Subject: Addendum 3, Bid FB-25-02, Camarillo Heights STEM Academy, Campus
Fire Alarm Upgrades

Project: Cam Hts FA
Subject: Bid RFI response

School Name: <u>Camarillo Heights Stem Academy</u>		DSA Application No.: _____
Project Name: <u>Campus Fire Alarm Upgrade</u>		RFC Number: <u>TVI-01</u>
Project Description: <u>Fire Alarm</u>		Date: <u>3/5/2025</u>
Issued To: _____ (Architect)		Project No.: <u>FB-25-02</u>
_____		Contract No.: _____
_____	_____	E650
Drawing Number Detail	Specification Section	Page

REFERENCE ONLY
SITE PLAN & DETAILS

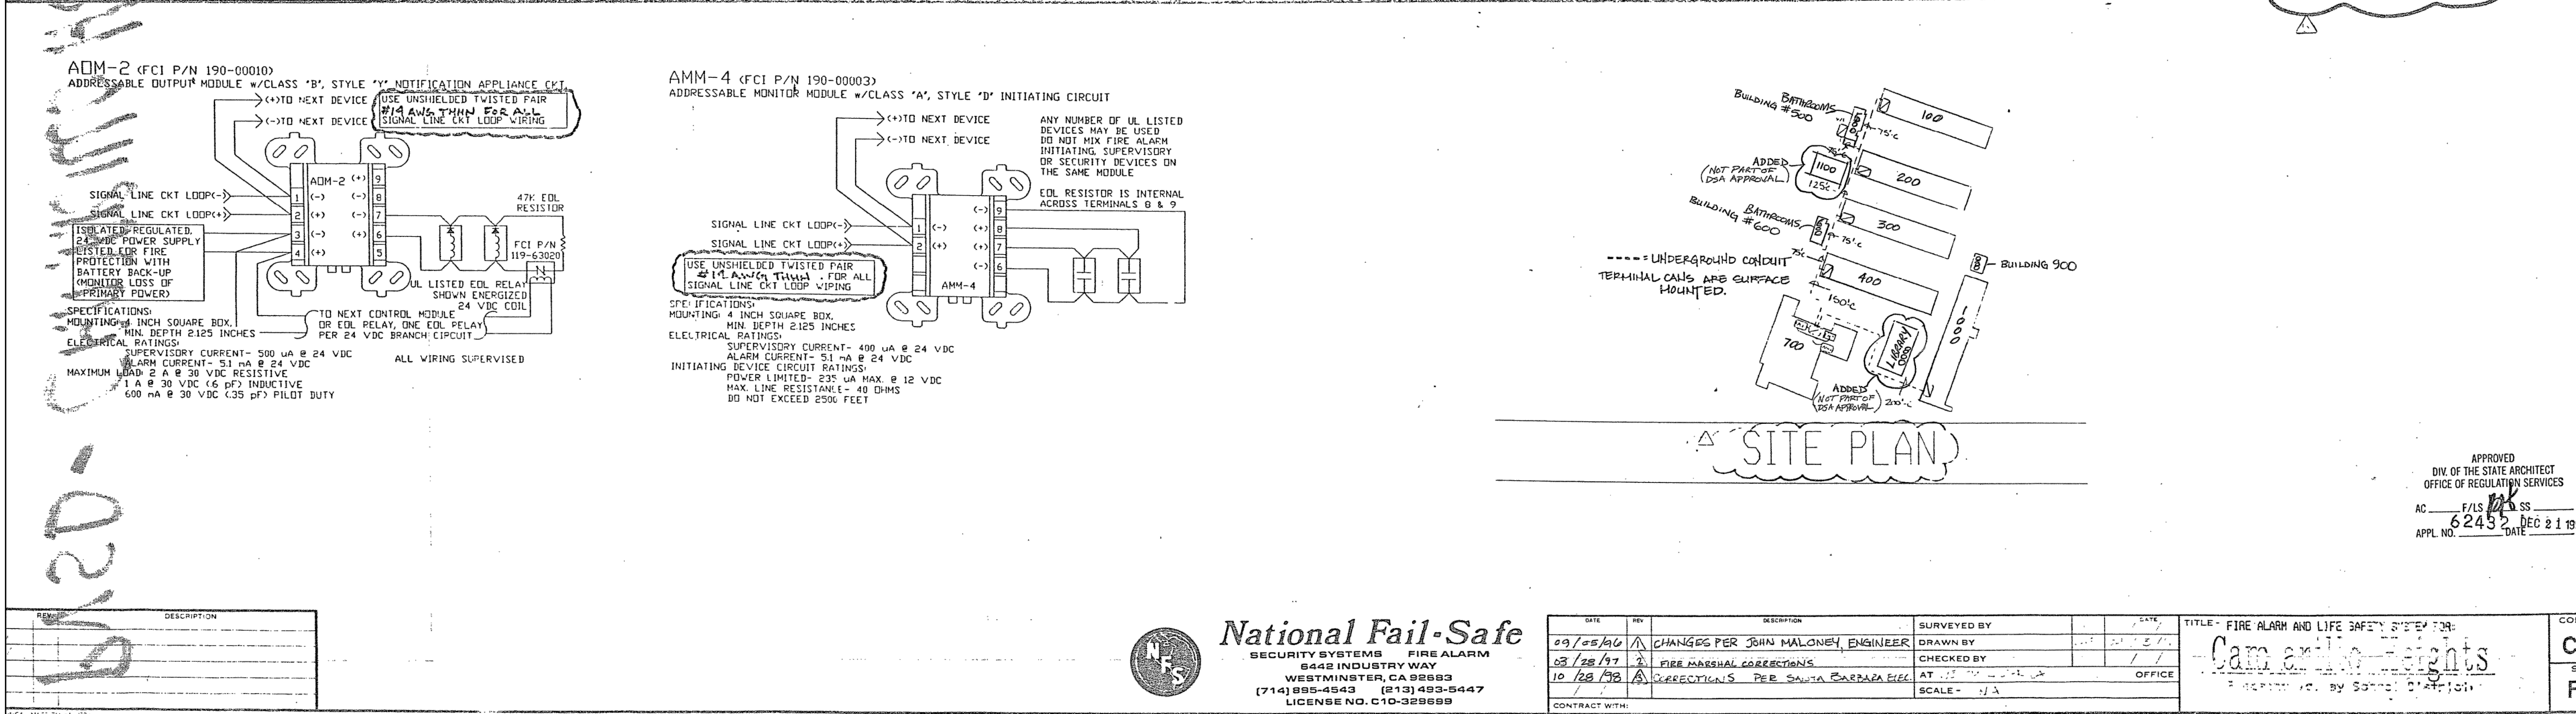
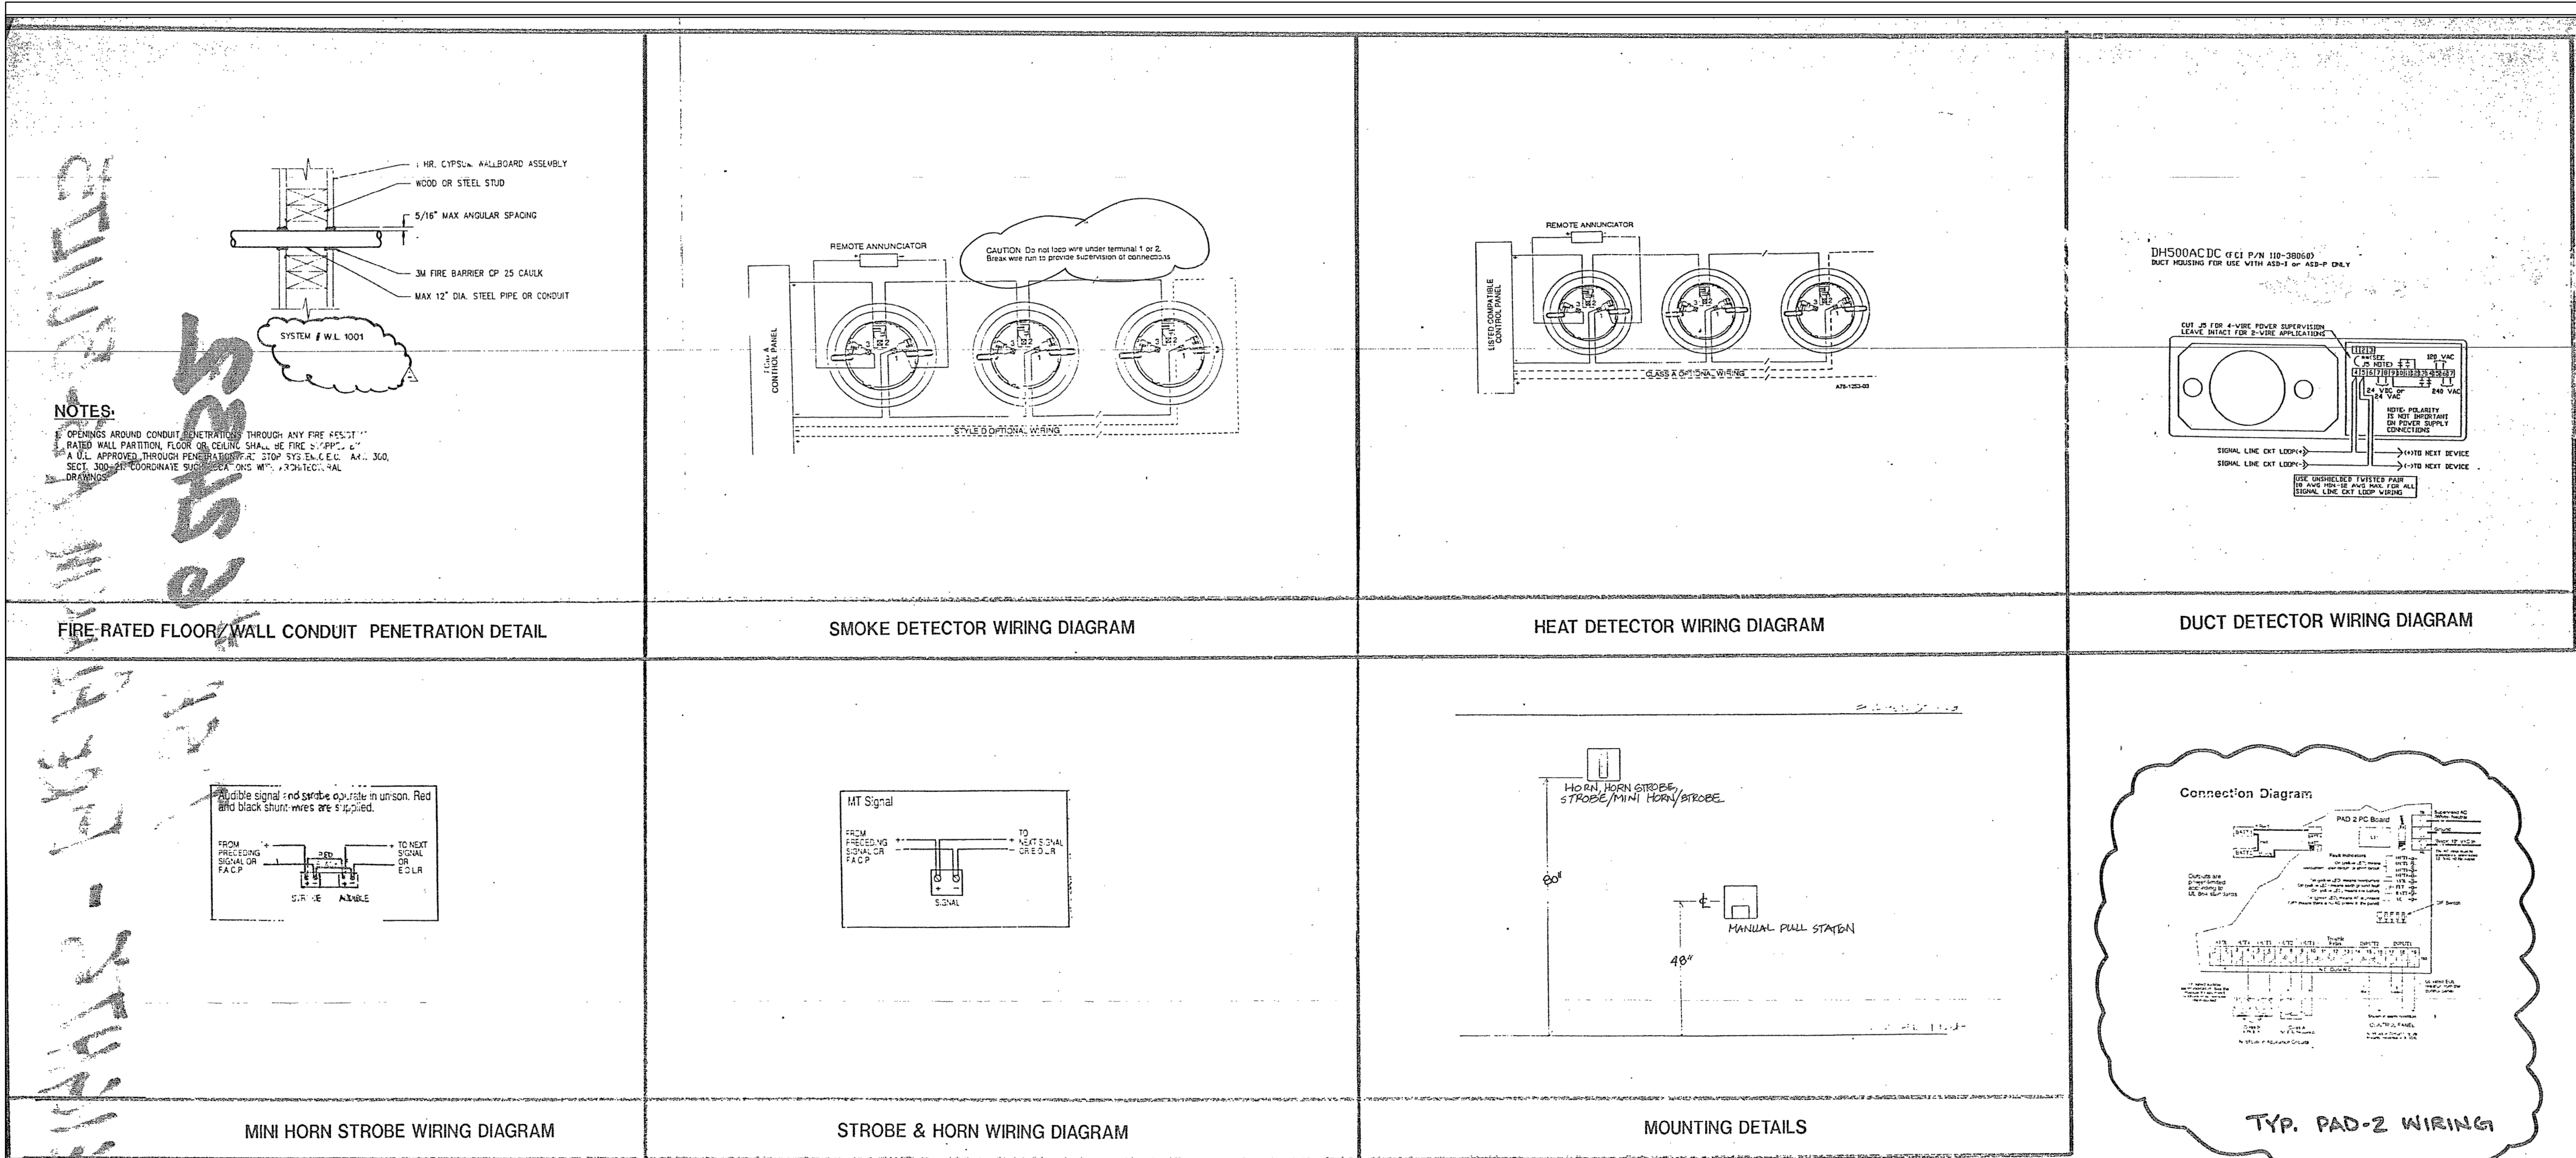
Is demolition of existing fire alarm system part of the scope of work? If so, please provide plans showing existing devices.

Yes, as noted on the plans (contract docs) the existing FA system is to be removed after the new system is installed. Please note the attached plans for existing condition from the existing as built.
